WBC Highway Comments

MEMORANDUM

From:	Gordon Adam Development Control		
Service	SDL Highways	App No:	242279
Address:	Land west of Old Wokingham Road and North and South of, Easthampstead Road, Wokingham, (Proposed SDL Extension).		
Proposal:	Outline application with all matters reserved except means of access for up to 180 dwellings and associated infrastructure including open space, play space, landscaping, SuDs and green infrastructure. Please note: The application has been submitted in relation to the area proposed as an extension to the South Wokingham SDL in the Local Plan Update(LPU).		
Type of Development:	Major Dwellings (10+)		
Site Visit Made:	Yes/No

DESIGNERS RESPONSE

Scale	Date	Drawn	Checked
1:500 @ A1	JAN 2024	TDM	NB
Drawing No A218-029			Revision P6

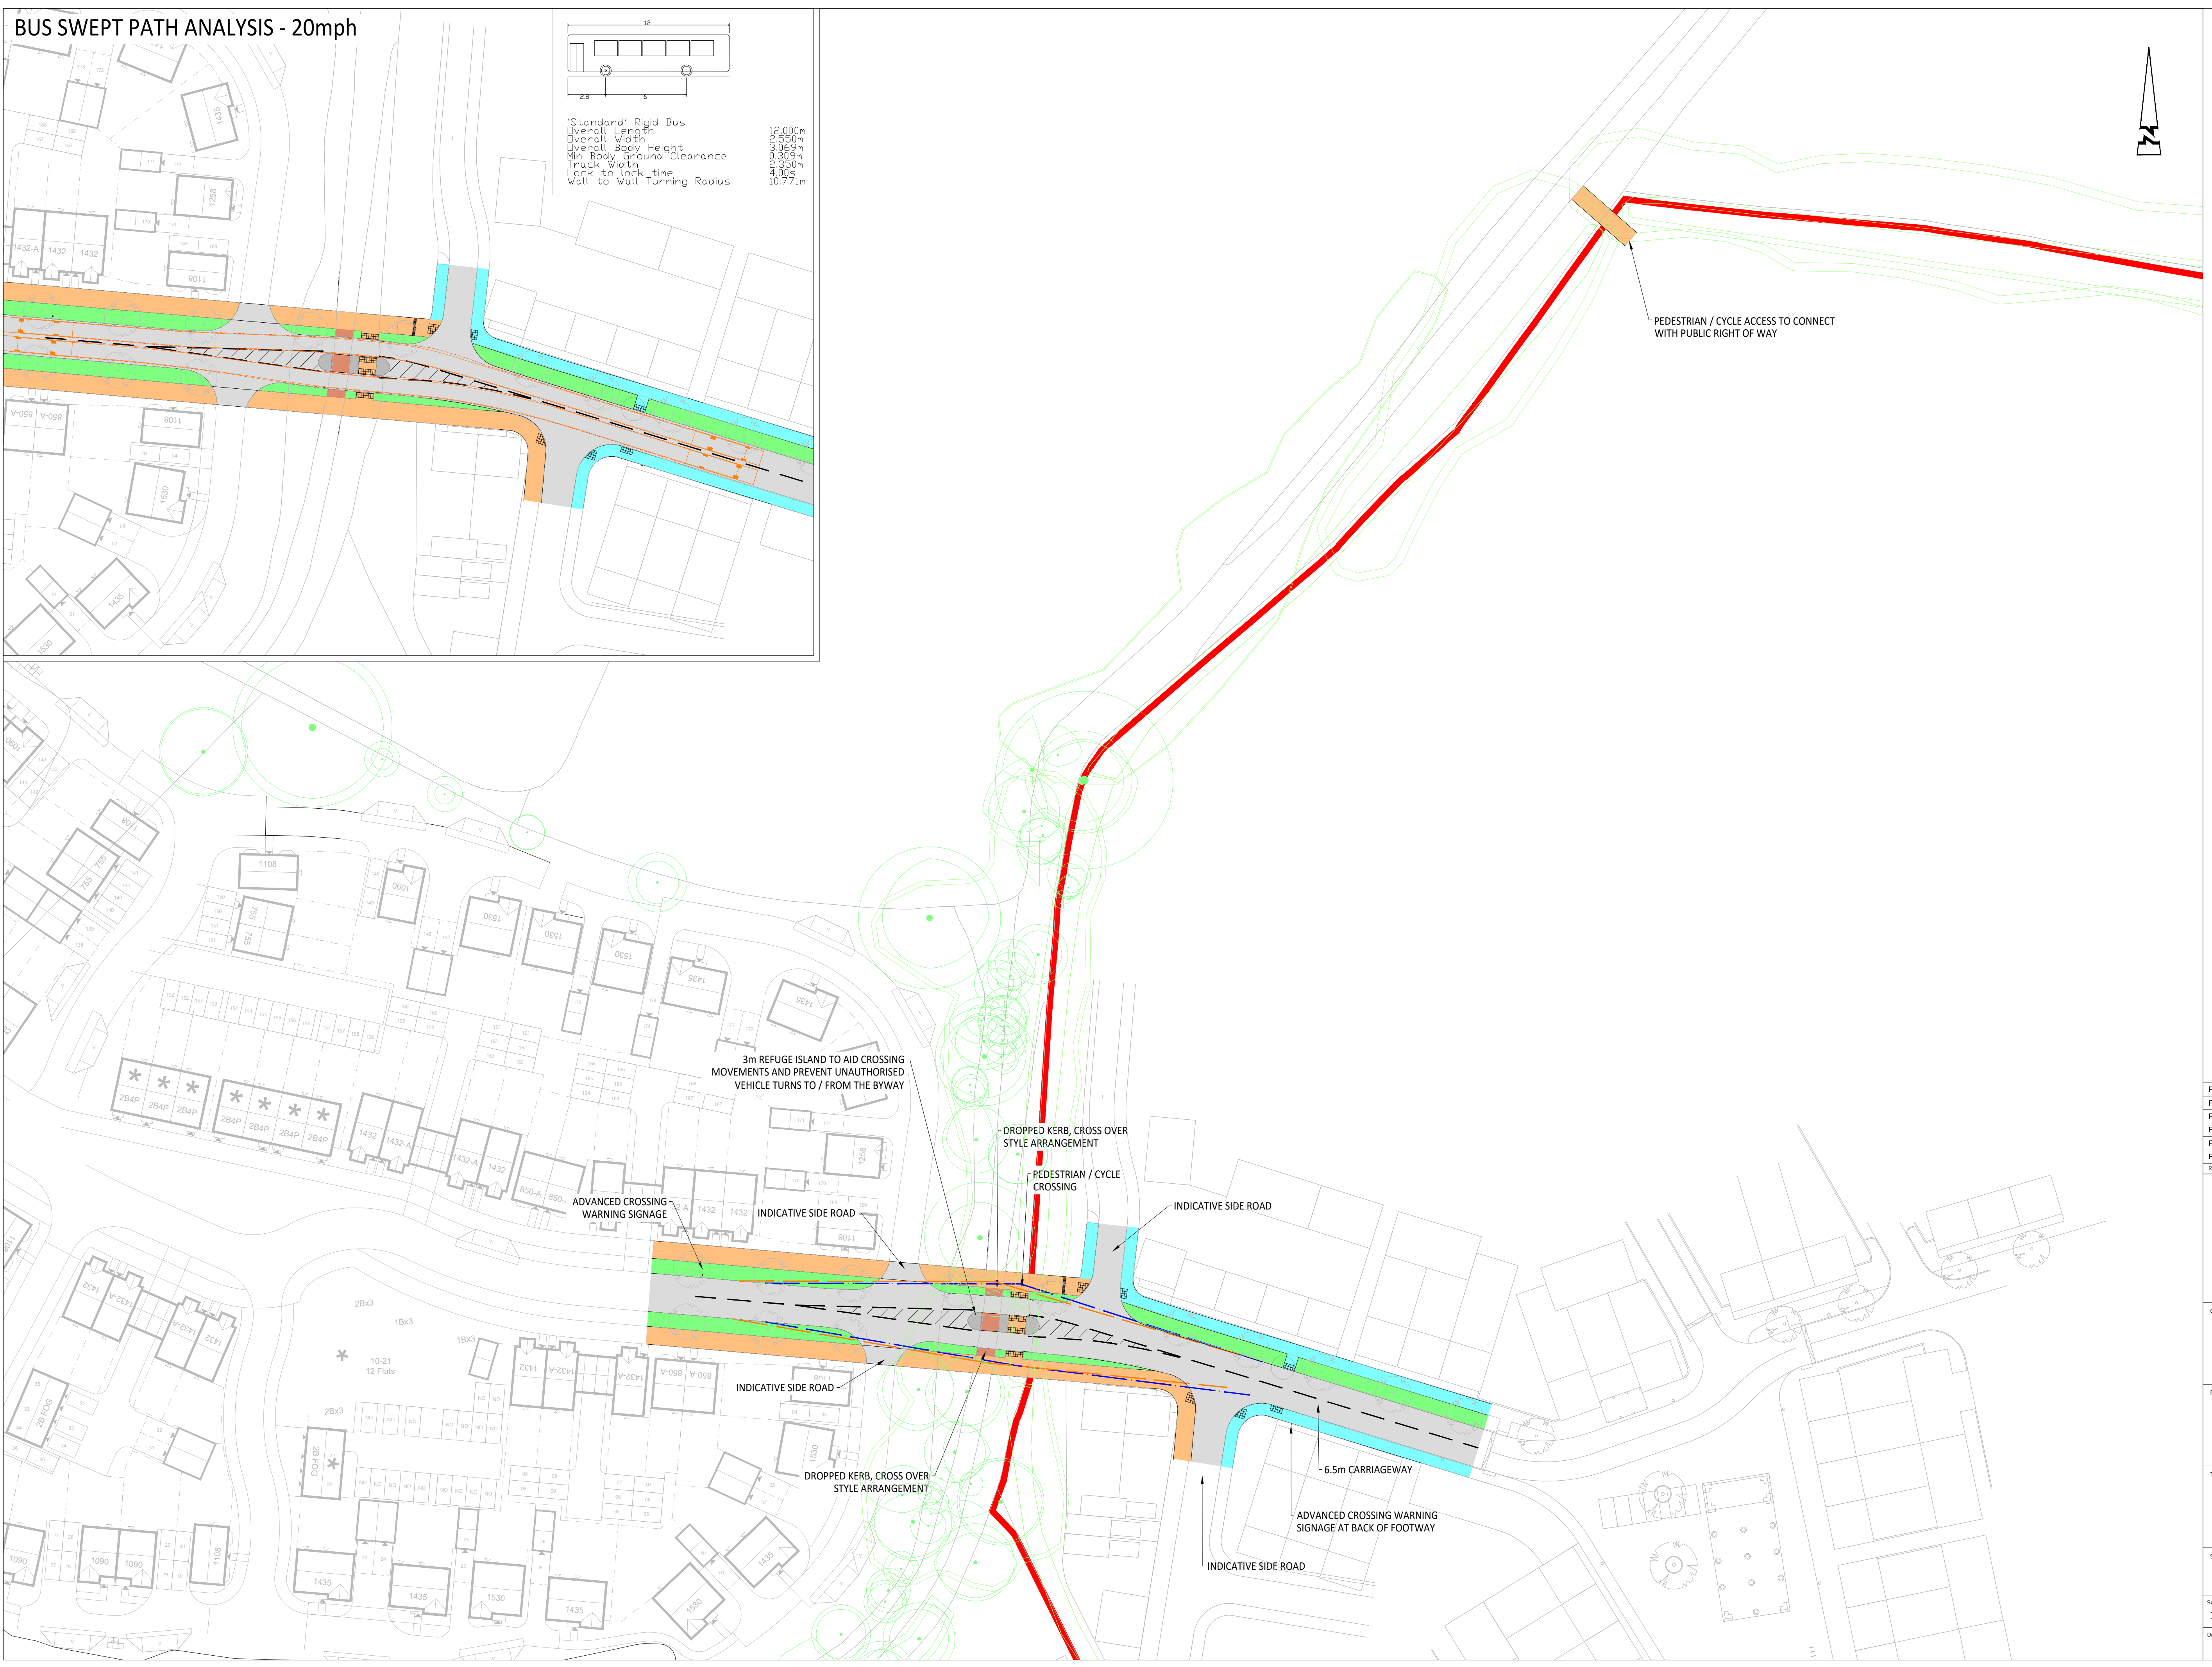
2.1.3 Provide illuminated or reflective bollards at either end of the island.

- 2.3.3 Provide corduroy tactile paving and appropriate path signage at this point.

- 2.4.3 Provide appropriate tactile paving and ensure the signpost does not conflict with or obstruct the crossing

- 2.5.3 Provide swept path drawings to show that large vehicles can turn out of the side roads and negotiate the island safely

2.2.4 *Agreed; road markings redrawn to provide 300mm offset from kerb.*

- 2.5.4 *The side roads have been shown indicatively based upon the emerging masterplan, which is to be determined in detail at Reserved Matters. A swept path analysis of the layout will be undertaken as a part of RM application with appropriate adjustments to ensure vehicle movements are accommodated.*

- 2.7.4 *The landscaping proposals are currently indicative only. The detailed planting strategy will ensure appropriate visibility is maintained at the crossing.*

- 2.8.4 *Corduroy paving has been added to the proposed crossing arrangement to indicate the shared footway/cycleway is terminating.*
